ADDENDUM #1

Bid #26-21

Maplewood Ave Traffic Signal Mounted Luminaires

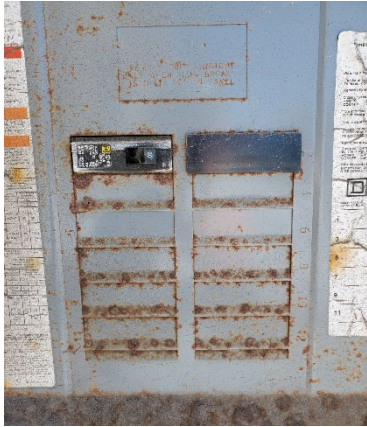
The Hanover St Signal cabinet subpanel is fed from the Deer St cabinet with a 60 Amp double pole breaker. Install a new Square D QO breaker for the lighting in the sub-panel. Pass through the cabinet wall with the wire and into the conduit system which begins inside the cabinet. The 20 amp breaker shown below is the only breaker currently in the panel and runs the signal. Picture of inside the Hanover sub-panel:
